Department of Energy
Washington, D.C. 20545

Docket No. 50-537
HQ:S:82:036

RESPONSES TO REQUEST FOR ADDITIONAL INFORMATION - POWER SYSTEMS

Reference: Letter, P. S. Check to J. R. Longenecker, "CRBRP Request for
Additional Information," dated March 16, 1982

FIGURE 8.3-6 ARRANGEMENT WHEN HORIZONTAL SPATIAL
SEPARATION IS NOT MAINTAINED
NON-HAZARD ZONES.

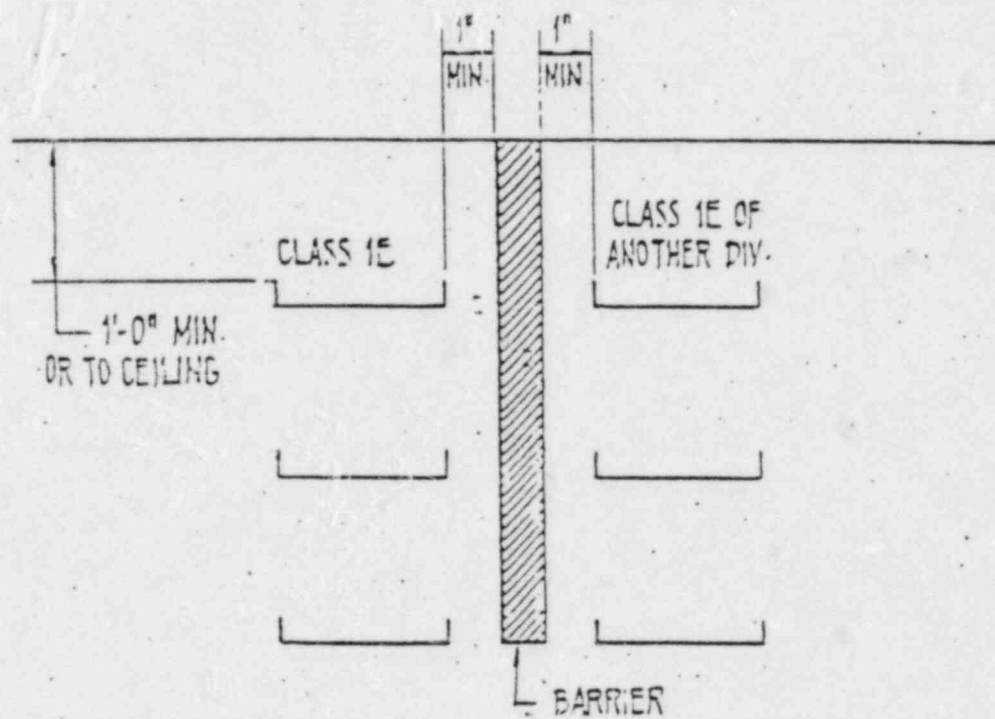
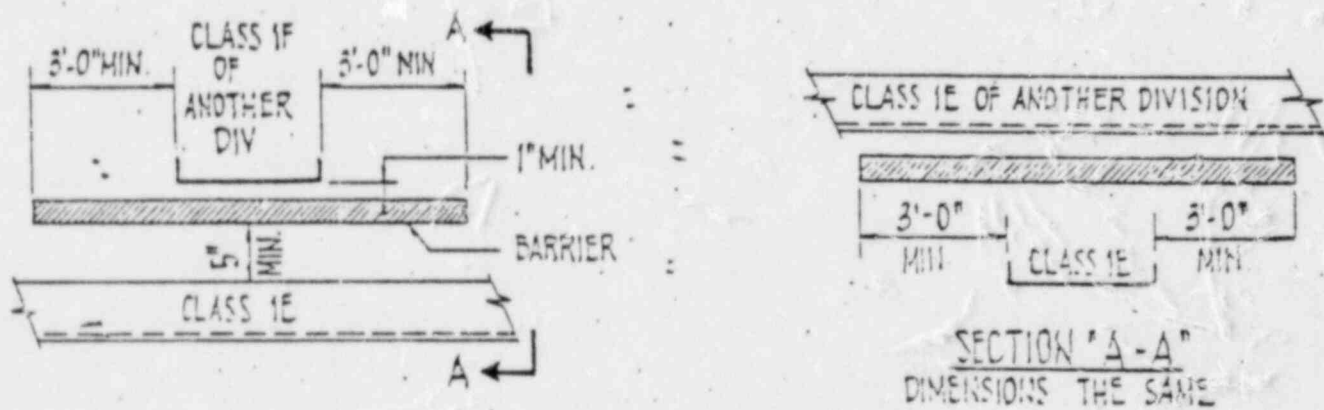
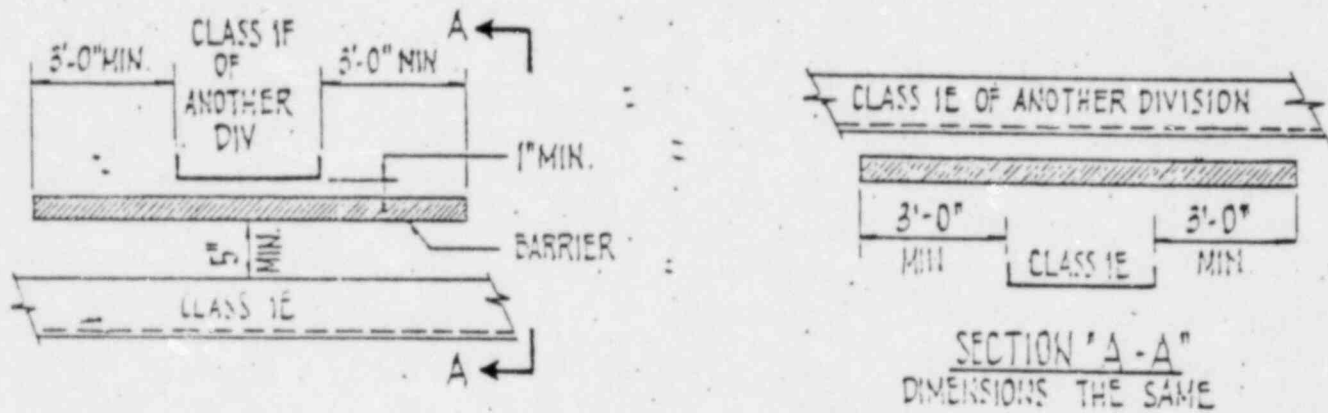
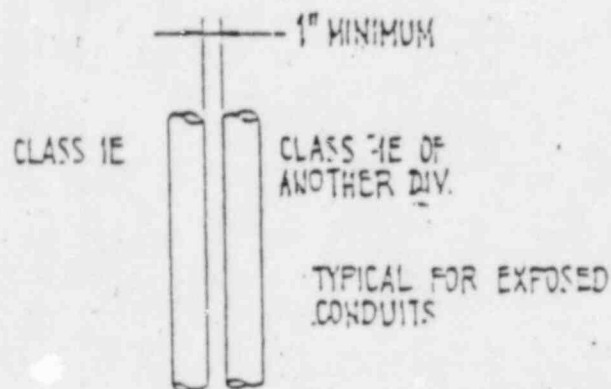
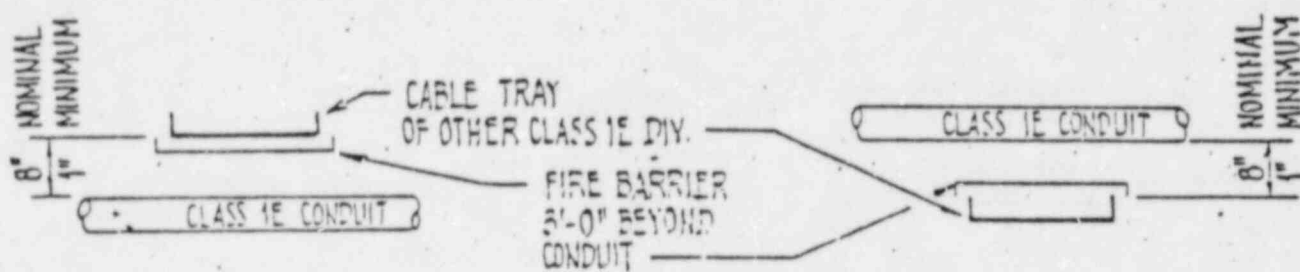
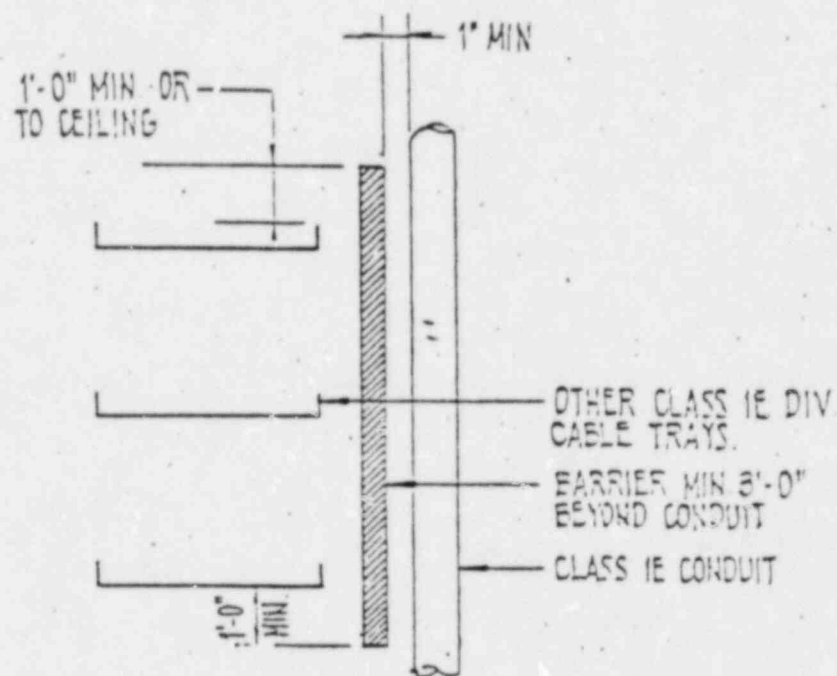
Section 8.3.1.2.14 of the PSAR indicates that physical separation of circuits and equipment comprising or associated with the Class 1E power system, Class 1E protection systems and Class 1E equipment, will be in accordance with criteria set forth in paragraph 8.3.1.4 of the PSAR. Separation criteria described in Sections 8.3.1.2.14 and 8.3.1.4 of the PSAR is not clear and does not meet the guidelines of IEEE Standard 384 and Regulatory Guide 1.75. For example, the PSAR indicates that non-Class 1E cables in panels will be separated from Class 1E cables so that they will not provide a combustion path between different divisions. Section 5.6.5 of IEEE Standard 384-1974 states that non-Class 1E cables shall be separated by six inches or a barrier. In general no criterion has been described for separation of Class 1E and non-Class 1E cables. Other examples include: (1) no criteria for separation between cables trays and conduits of another division, (2) confusing criteria for the separation of the third division (the design indicates there are three divisions but only two redundant divisions. Separation criteria refers to only two redundant divisions in many cases versus the three divisions), (3) confusing definition for associated cables, (4) no criteria for separation between associated cables and non-Class 1E cables, and (5) no criteria before and after an isolation device. Revise your PSAR description of physical separation of circuits to comply with the recommendations of IEEE Standard 384-1974 and guidance of R.G. 1.75 or justify noncompliance.

In Non-Hazard Zones, exposed conduits of different Class 1E divisions are routed as far as possible apart, preferably on opposite sides of the walls. Parallel routing of conduits of different divisions is avoided. If the design makes it unavoidable a minimum of one (1) inch spatial separation is provided between conduits of different Class 1E divisions as shown in Figure 8.3-6. When the safety related conduit cross or run parallel to another safety related tray the minimum horizontal and vertical clearance is the same as provided for cable trays of different Class 1E divisions. If this clearance is unavoidable, a barrier is provided between the safety-related conduit and cable trays of other Class 1E divisions as shown in Figure 8.3-6.

In Non-Hazard Zones, a minimum horizontal clear space of three feet is maintained between cable trays of different divisions as shown in Figure 8.3-6. If a horizontal clearance of less than three feet is unavoidable, a fire barrier is provided between the divisions as shown in Figure 8.3-6.

Vertical stacking of cable trays of different divisions is avoided wherever possible. Where cable trays of different divisions are stacked vertically, a minimum clear space of five feet is provided between the divisions as shown in Figure 8.3-6. If a vertical clearance of less than five feet is unavoidable, a fire barrier is provided between the divisions as shown in Figure 8.3-6.
